**First Columbia (Parcel E)
Concept Plan**

**FIRST COLUMBIA
PARCEL "E"
CONCEPT PLAN
(SPERRY)**

TOWN OF NEW WINDSOR
PLANNING BOARD
REVIEW COMMENTS

PROJECT NAME: FIRST COLUMBIA SITE PLAN
(PARCEL 'E' DEVELOPMENT PLAN)
(A/K/A NEW YORK INTERNATIONAL PLAZA)

SP-1

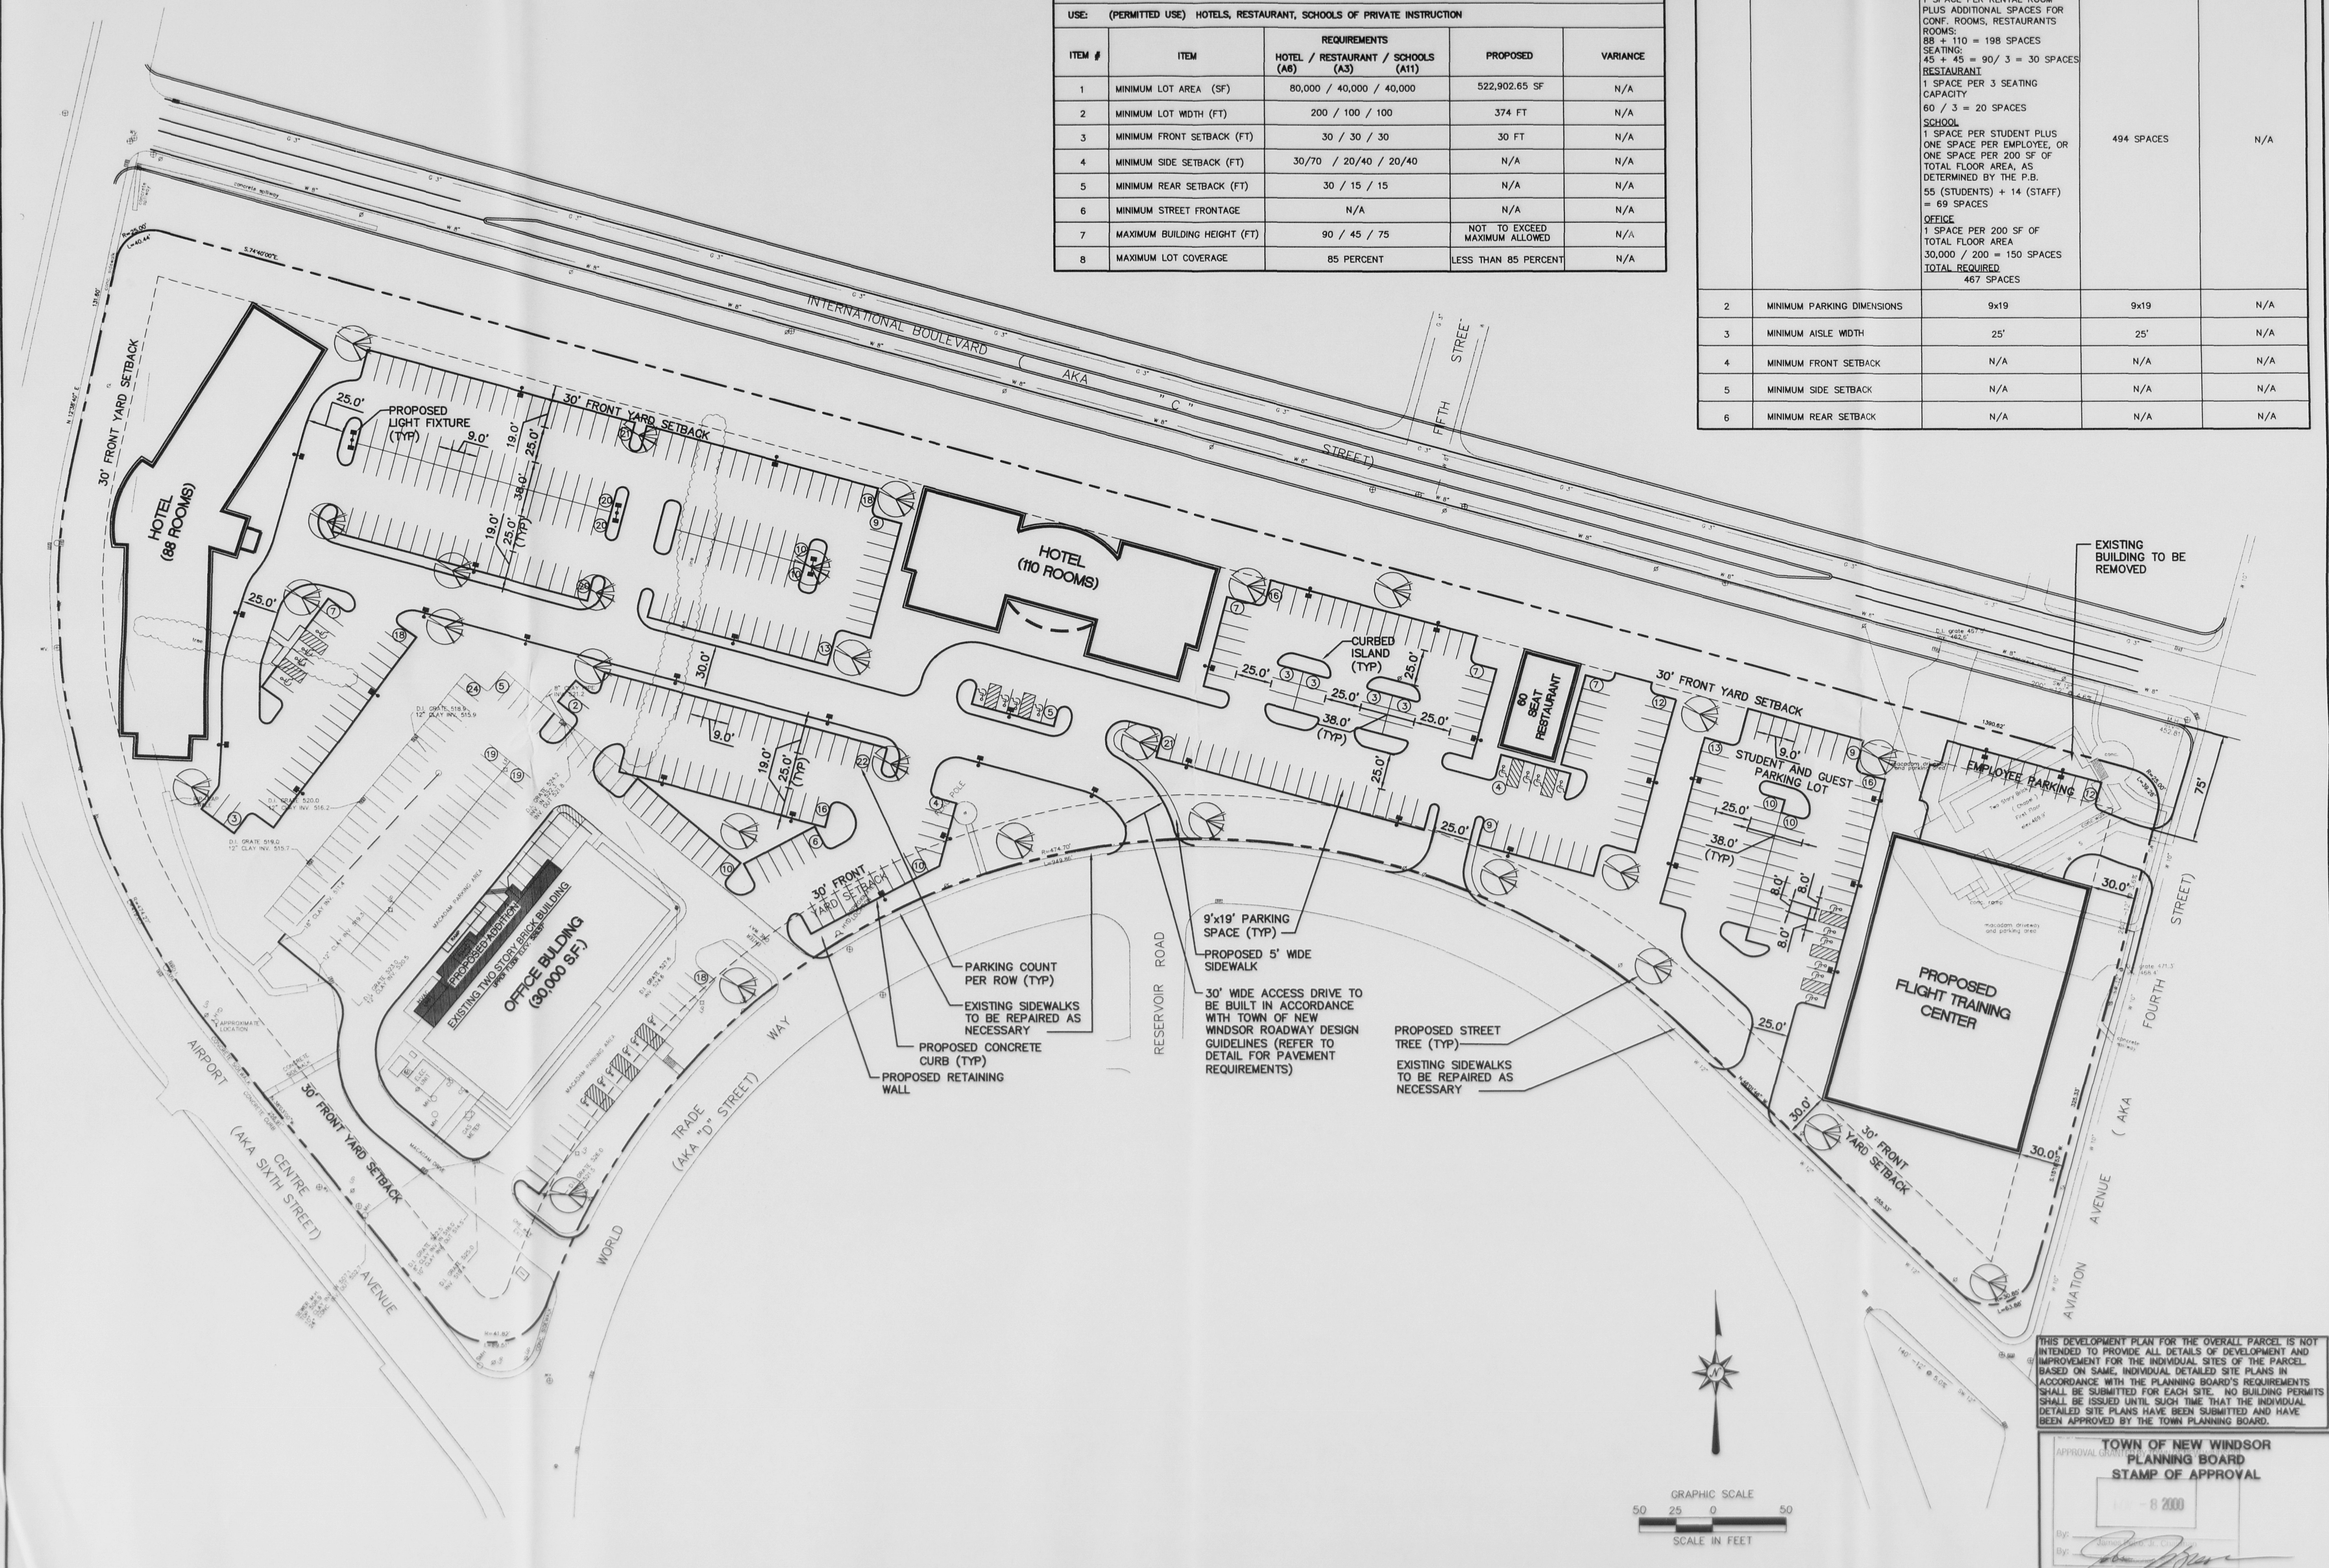
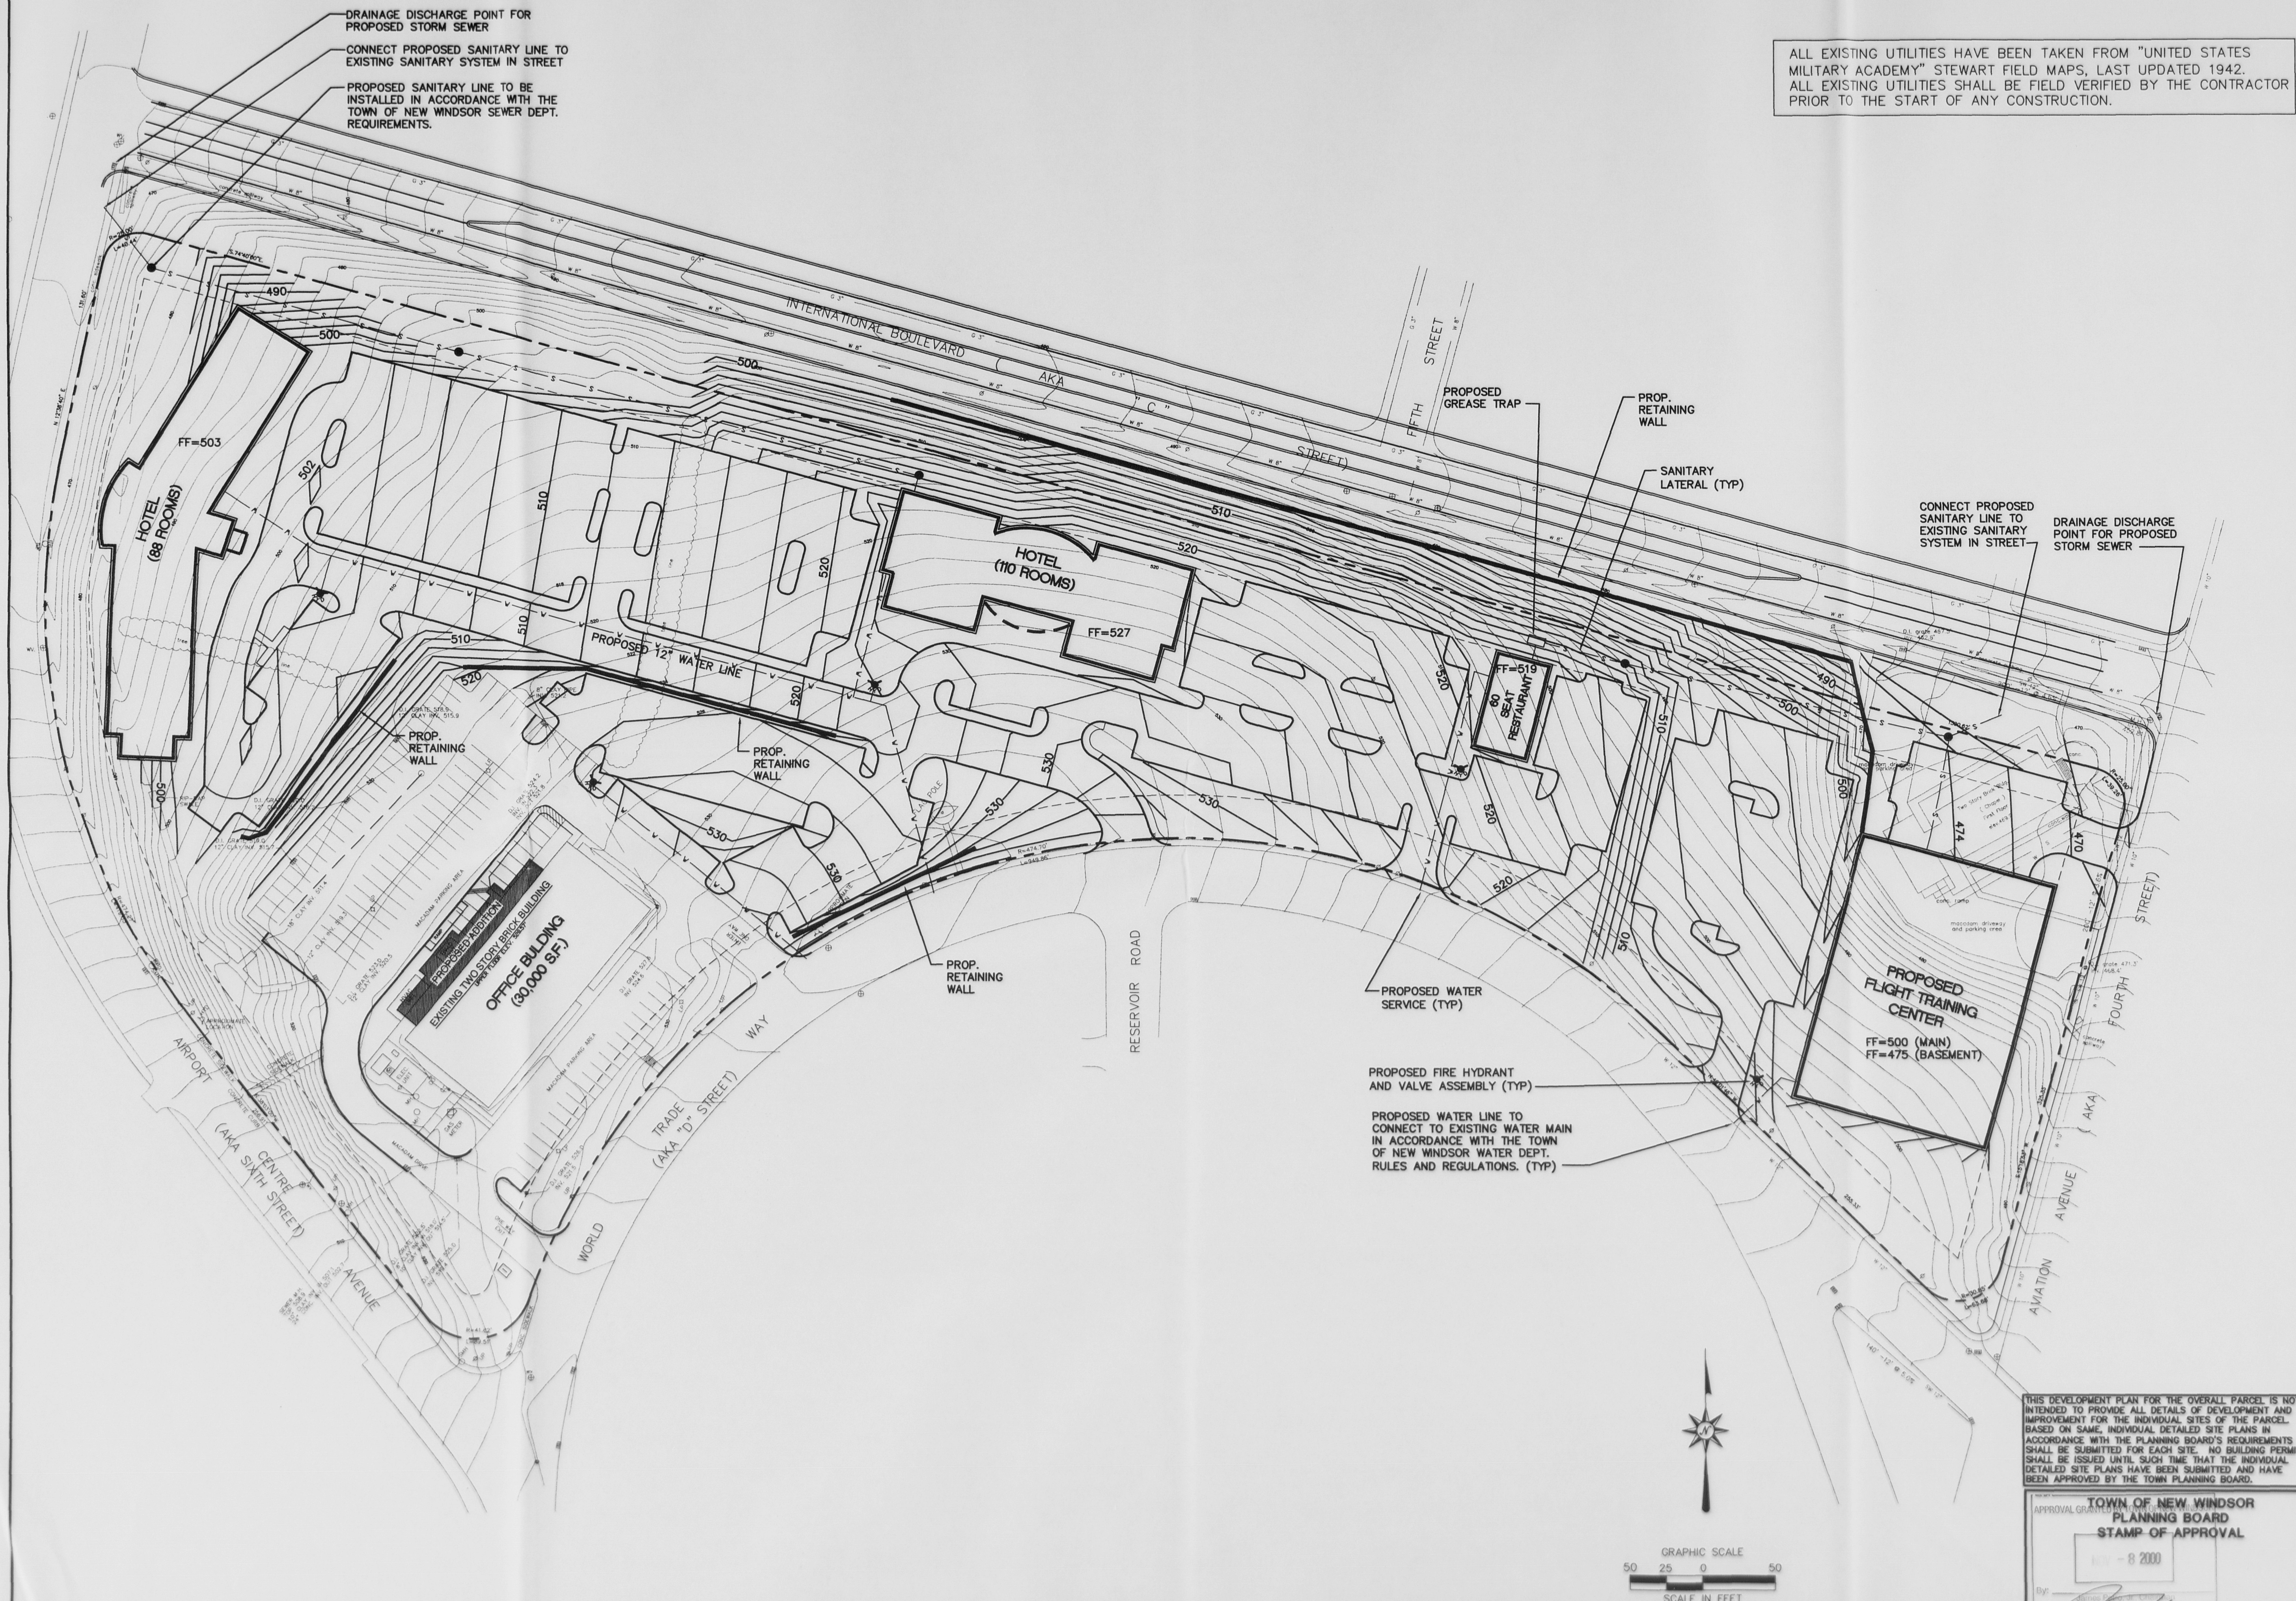
1. This property is located in the Airport-1 (AP-1) Zoning District of the Town. The "required" values for each use classification appear correct, and the applicant has made all the requested corrections to the table.
2. With regard to the parking calculations on the plan, they appear acceptable, and the applicant has adjusted the calculations to consider possible meeting rooms and restaurant uses in the hotels.

3. Regarding the site plan and grading/utility plan, I have the following comments:
 - a. The applicant has revised the plan to make it more legible so the contours can be followed. I believe the rough grading plan as depicted is acceptable.

- b. The water line routing has been revised and the main feed is now 12" dia., as required by Town standards.
 - c. The plan notes a drainage discharge point at the corner of the site. This will presumably connect to the existing system running down International Boulevard (f/k/a C Street), which consists of 12" and 15" piping, ultimately discharging to a 36" pipe along Breunig Road. I believe this development will require a replacement of the piping along International Boulevard. (Also see comments below regarding SEQRA).

- d. The plan indicates sewer connections to an existing sewer manhole in the area of International Boulevard and Aviation Ave (f/k/a Fourth St.). This would appear acceptable, although it should be noted that sewer main extensions are required to serve the buildings. Approvals for the extensions must be obtained as part of the individual site plan applications.

1. This property is located in the newly created Airport-1 (AP-1) Zoning District of the Town. Although I have not received the "official" copy of the code update, I have compared the bulk table on drawing SP-1 with my copies of the AP-1 table and the "required" values for each use classification appears correct. The following additions should be made to the table:
